PLANNING COMMISSION AGENDA

Thursday, February 20, 2014

Subject: PC 14-01, Amcon, Site Plan for a freight terminal and warehouse.

RE: Coon Rapids, MN
Magnum Trucking
Plan Review

SHEET NO. 3 OF 9

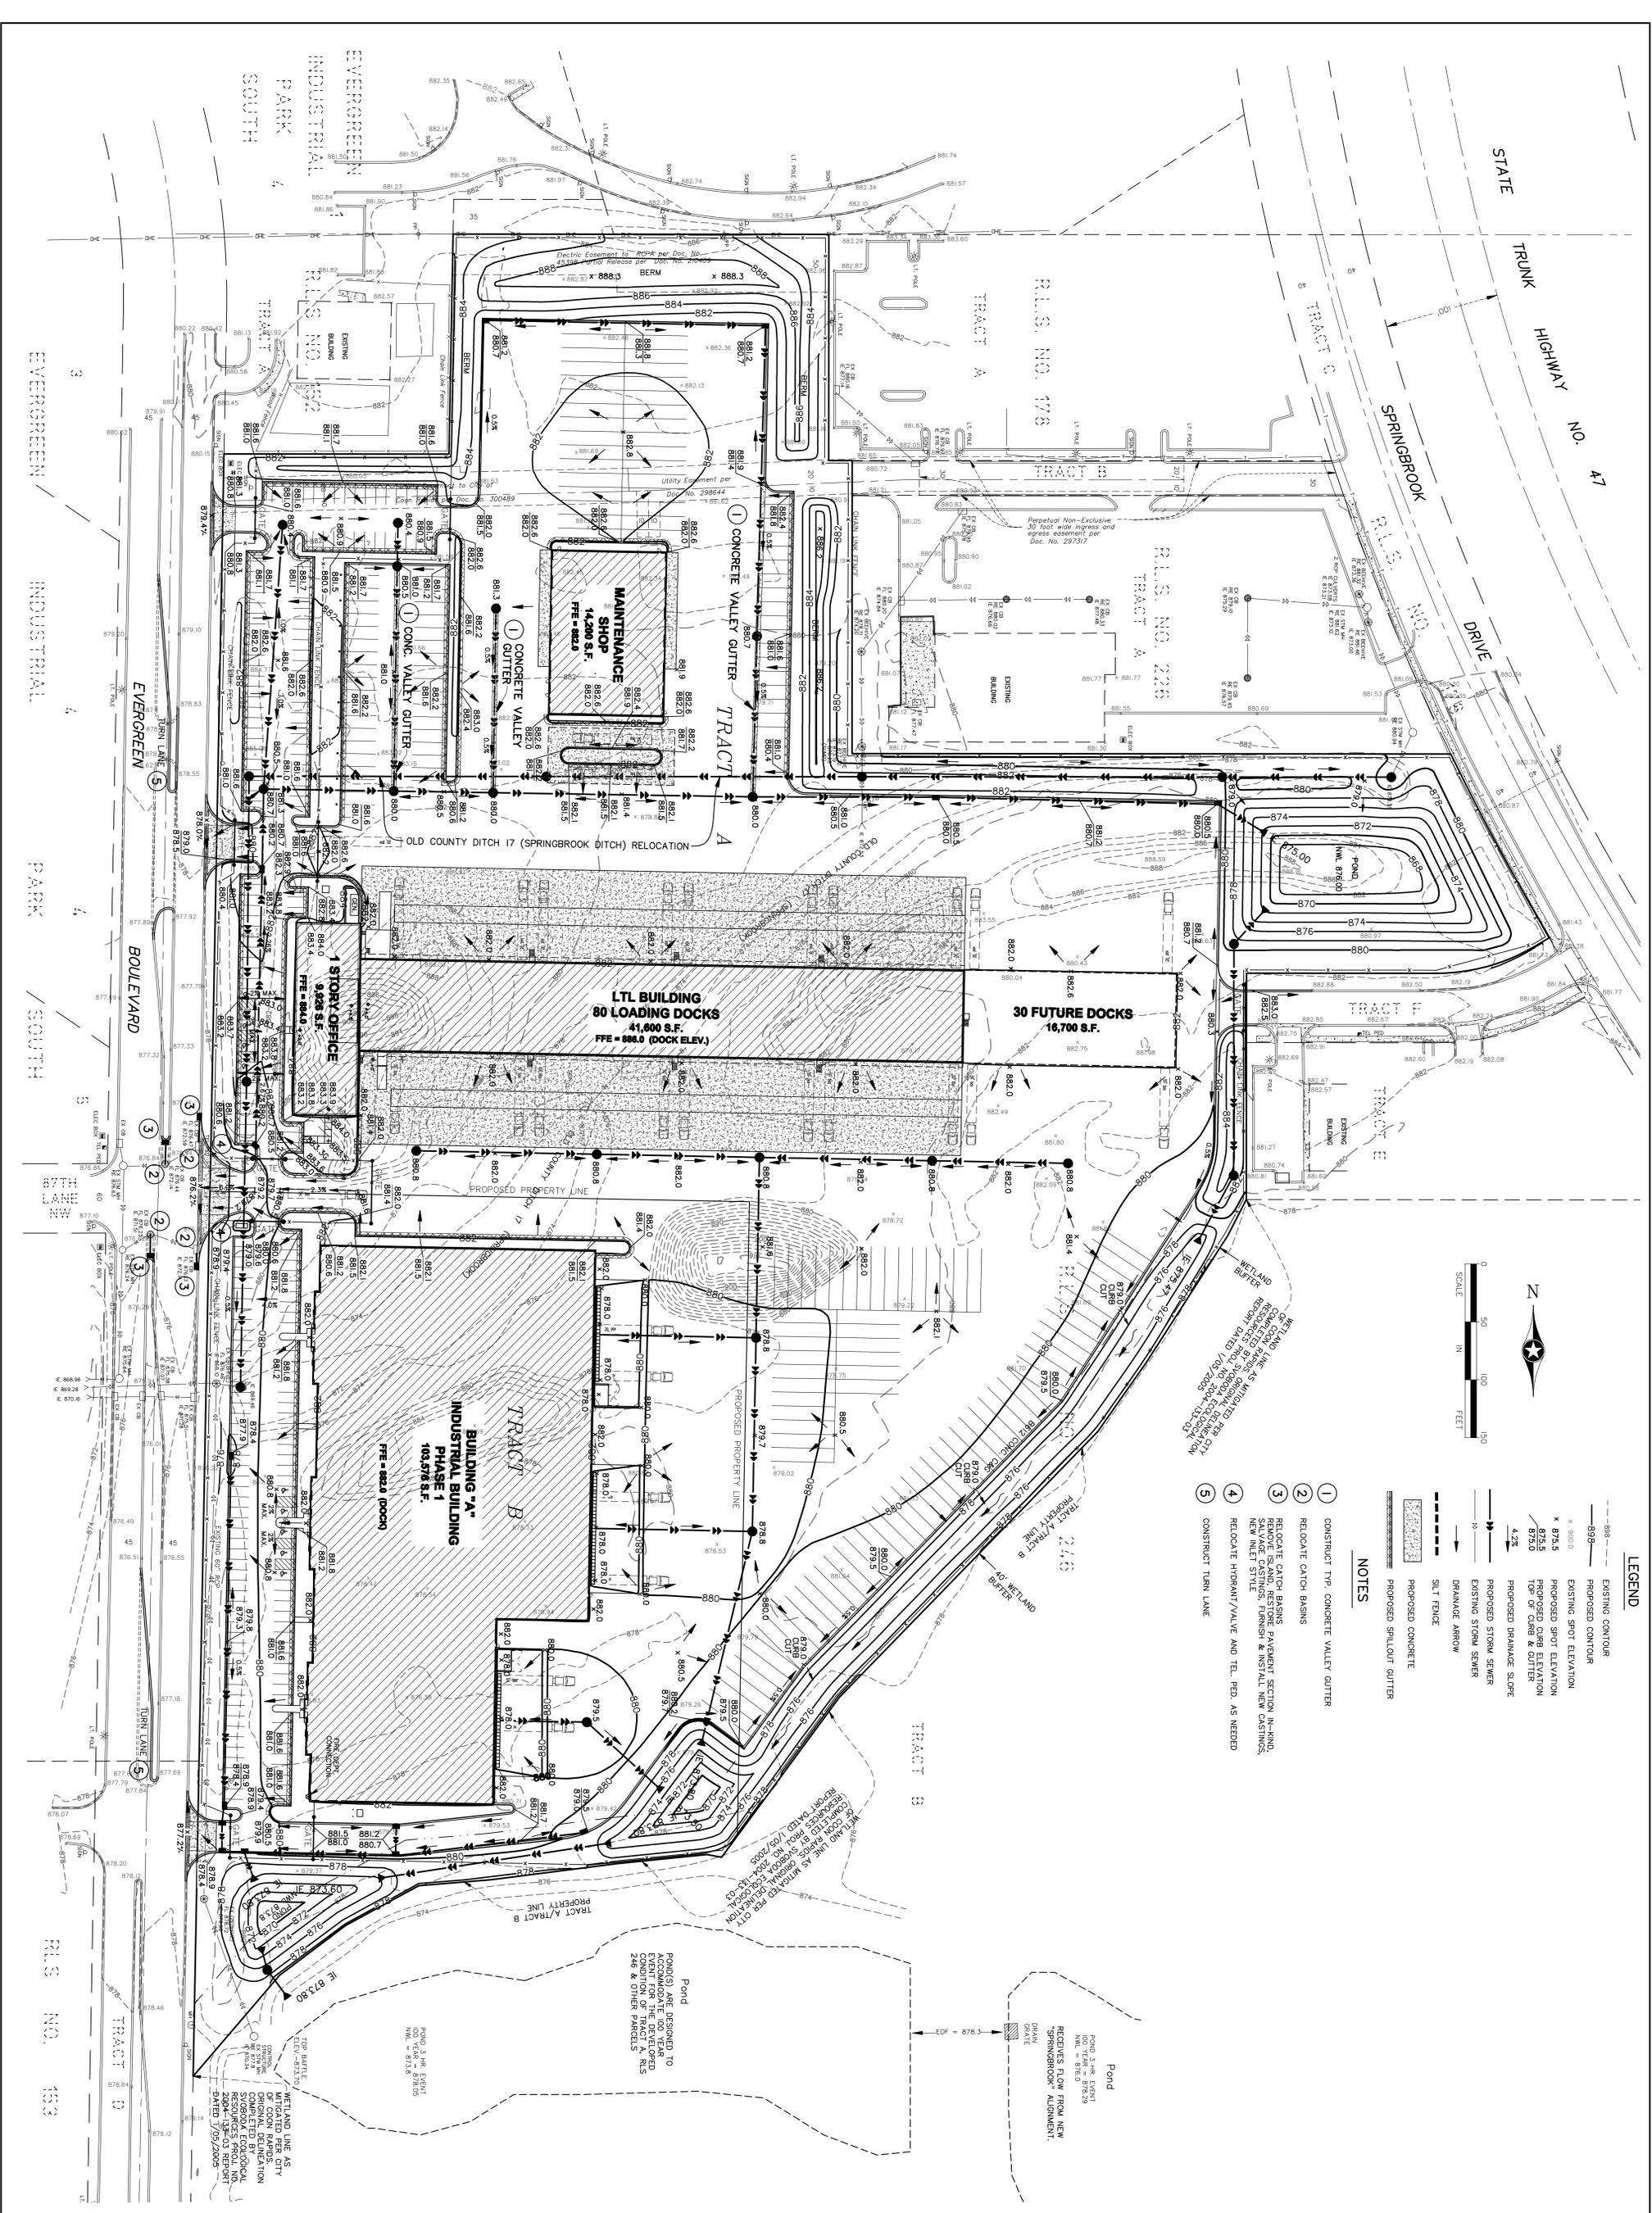
SHEET 3 of 6

- There is no information provided on the storm sewer pipe size, material or pipe class. This information needs to be included on the plan.
- There are no pipe grades or inverts shown on the plan. This information needs to be included.

- A report from the hydraulic modeling of the site was not submitted with the plans. Surface water and treatment facilities for the site will need to be reviewed and approved by Coon Creek Watershed District.

- The pipes in the center entrance cross. Please provide pipe invert information to ensure that the elevations will work.
- The outlet pipe from the northeast pond connects to the existing system just west of Building A. The invert in the tie-in structure is shown to be lower than the flared end section. Please confirm. If this is the case the pipe will hold water.

- It appears that portions of the median on Evergreen Boulevard are being removed for turn lane construction. Include spot elevations in these areas to verify that ponding areas will not be created. Reverse slope gutter may be required in some of these areas as well.
